SUBMITTER NO.	419	ISSUE REFERENCE:	12018 / 4000
Submitter Type	Government	TOR CATEGORY	Air Quality / Cumulative Impacts
Nаме	DERM	RELEVANT EIS SECTION	Section 2.2.6, Cumulative Impacts

WARATAH COAL | Galilee Coal Project | Supplementary Environmental Impact Statement – March 2013

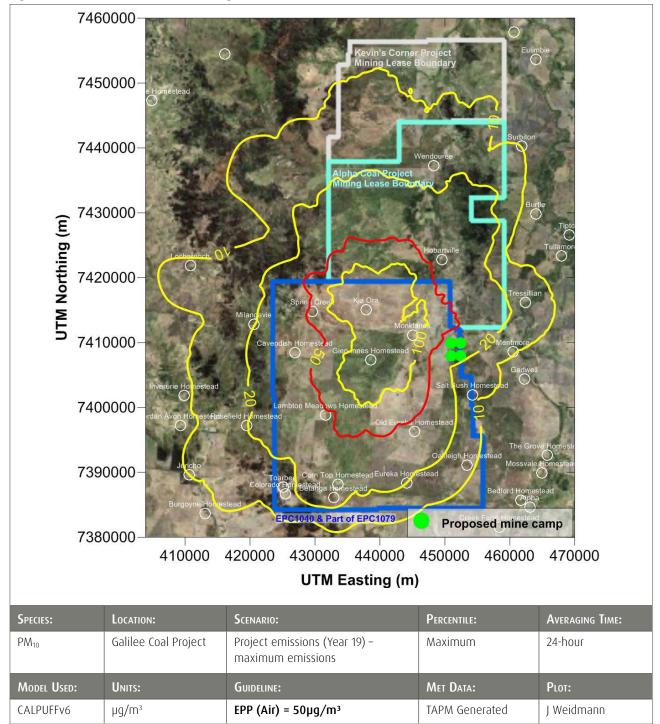
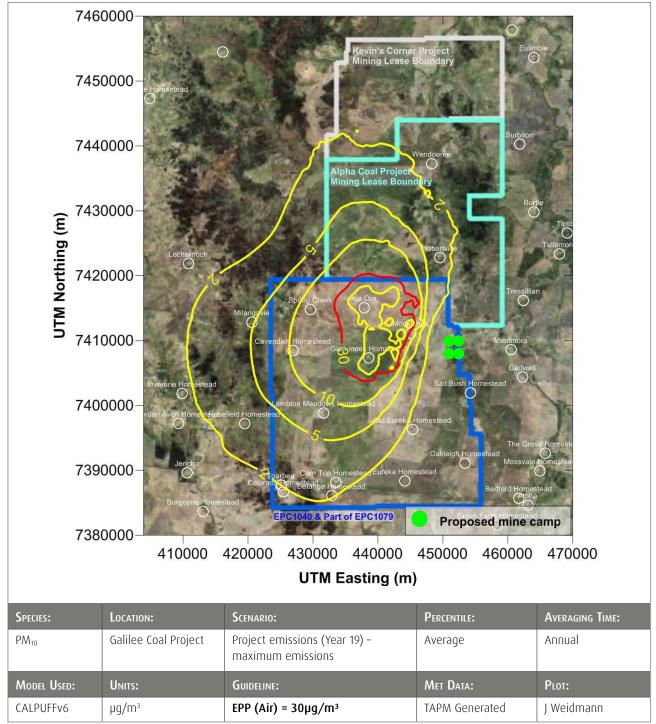
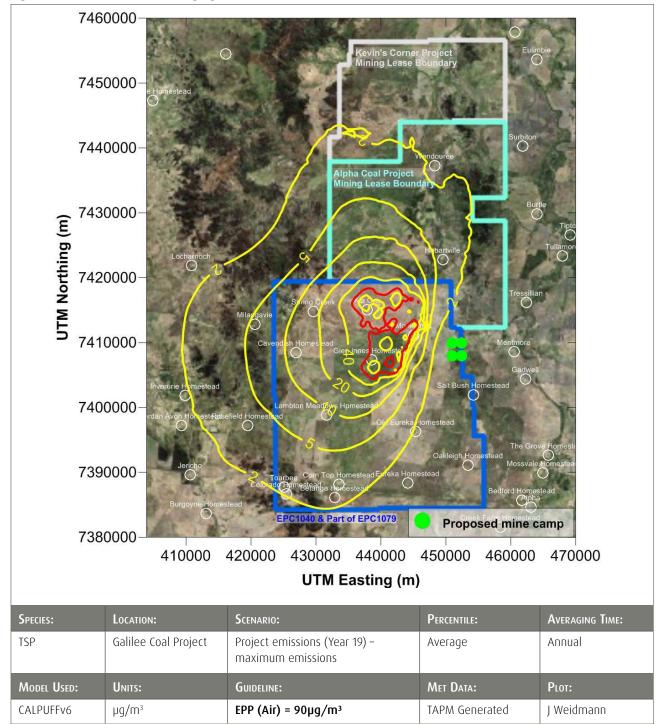
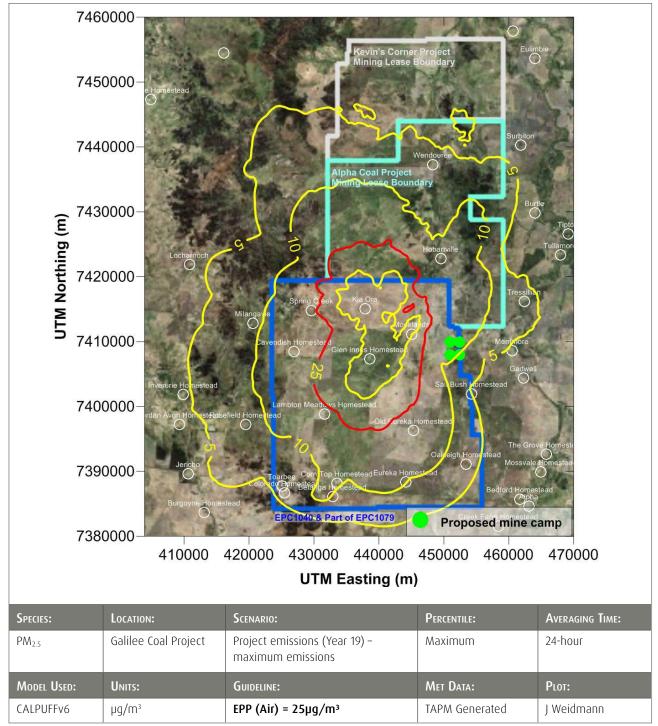
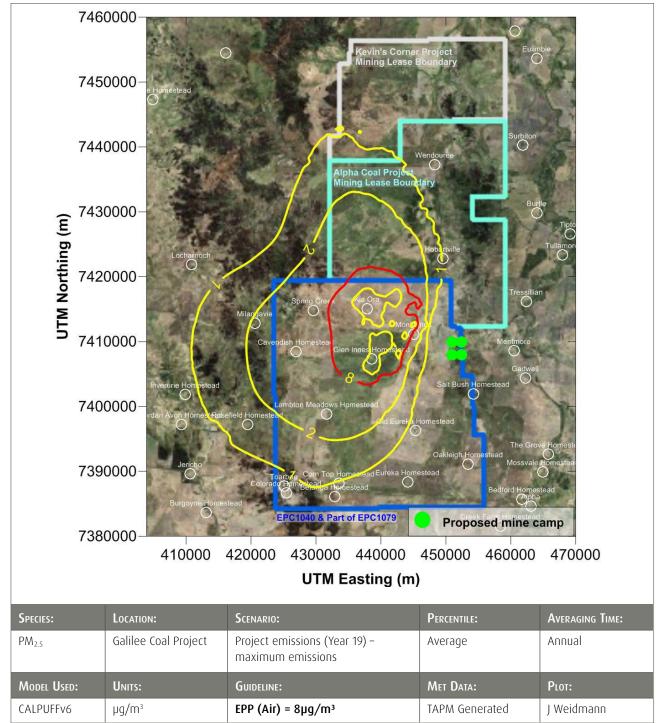
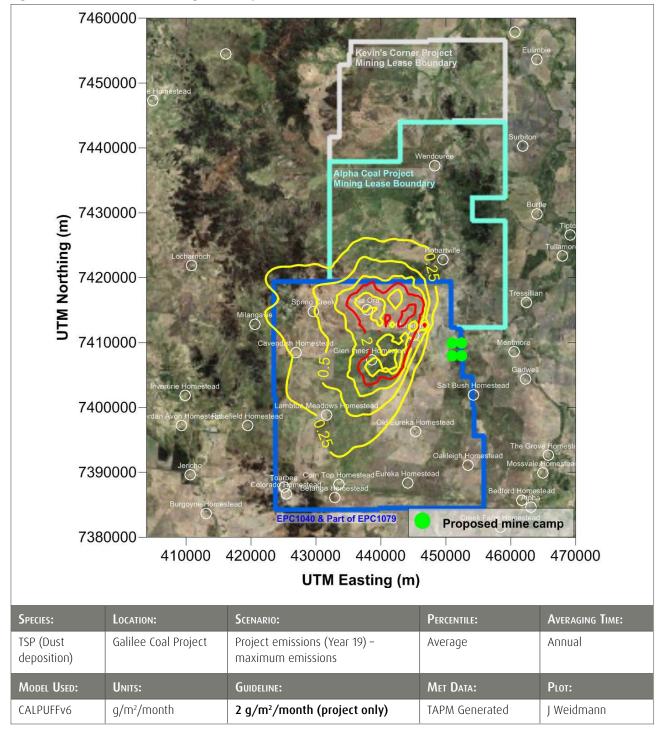
Predicted impacts in other EIS reports were not considered in predicting cumulative impacts. Section 2.2.6 stated that no EIS reports were available (in 2010) for Alpha Coal, Kevin's Corner and South Galilee Coal Projects, and their impacts would therefore not be assessed. This no longer correct as the Alpha Coal EIS has been published. The cumulative air quality assessment should be updated accordingly.

Based on the comments received in submissions and consequential revisions to emission estimates for the Galilee Coal Project, the air quality model has been revised to incorporate the following changes:

The revised emission estimates were included in a revised air quality model for the Galilee Coal Project using the same model set-up as previously assessed.

The air quality modelling results for the mine emissions only are shown in the following figures:
